APPLICATION NO.	FILING DATE	FIRST NAMED INVENTOR	ATTORNEY DOCKET NO.	CONFIRMATION NO.
10/709,743	05/26/2004	Bradley James Baxter	49925.830001.US0	3742

Application Number: 10/709,743  
Filing Date: May 26, 2004  
Appellant(s): BAXTER, BRADLEY JAMES

**EXAMINER'S ANSWER**

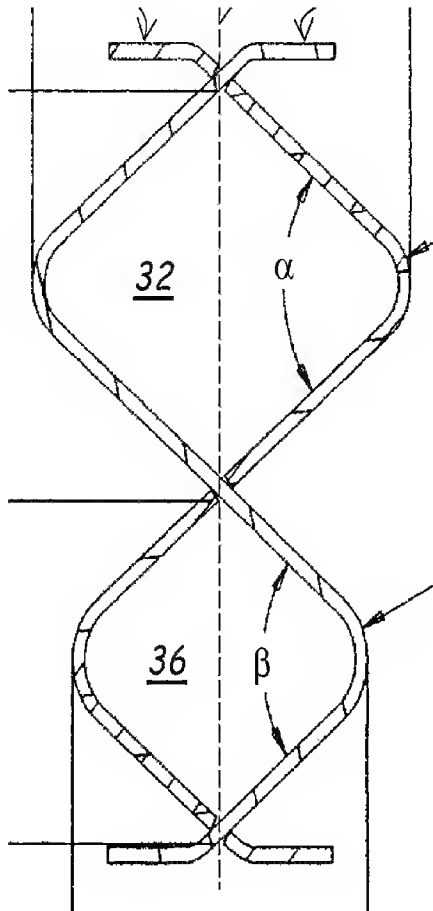
Appellant argues that the original claims recite "a first deformation member having a curved shape with at least first and second opposing radii of curvature in the direction of a deformation axis" which is the very definition of an S shape, however no basis or support for this definition can be found. The original disclosure fails to use the "generally S shape" terminology. Further, it is maintained that "s shape" is potentially narrower than the first and second opposing radii recitation. For instance, structure having a "z" shape can potentially meet the opposing radii recitation. The disclosure describes the instant invention as a diamond shape, not an "S" shape. The drawings don't appear to depict the element as being very s-shaped. It is unclear what it

encompassed by substantially and generally "S" shaped, particularly the scope of the terms "substantially" (claims 12 and 26) and "generally"(claim 1). The original disclosure fails to provide any indication of the degree of "S" shape required. As the original disclosure fails to use the generally or substantially S shaped terminology and the scope of the recitations is not clear, it is maintained that the limitations constitute new matter.

Bair et al (figure 4, rotated)

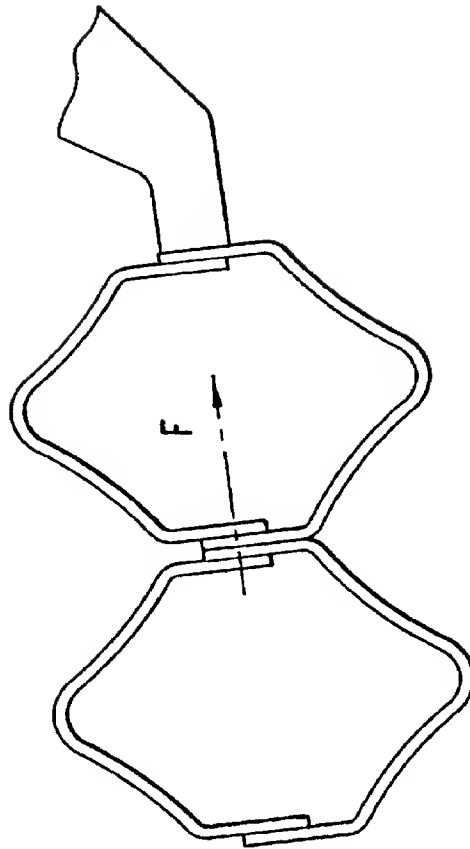
Appellant argues that the relied upon interpretation is improper as it redefines the prior art using applicant's disclosure, however the meaning of this is not clear. The Bair et al reference has been relied upon in an anticipatory rejection and has not been modified to meet the recitations of the instant claims; however, the claims have been given the broadest reasonable interpretation. It is maintained that the embodiment of figure 4 of Bair is fairly readable on the "s" shape recitation set forth by the claims. One side element of the first diamond and the opposite side element of the second diamond each form a deformation member. Nothing in the claim language precludes reading two of the c shaped elements of Bair on the "generally s shape" deformation member recitation.

It is maintained that the rejection is proper.
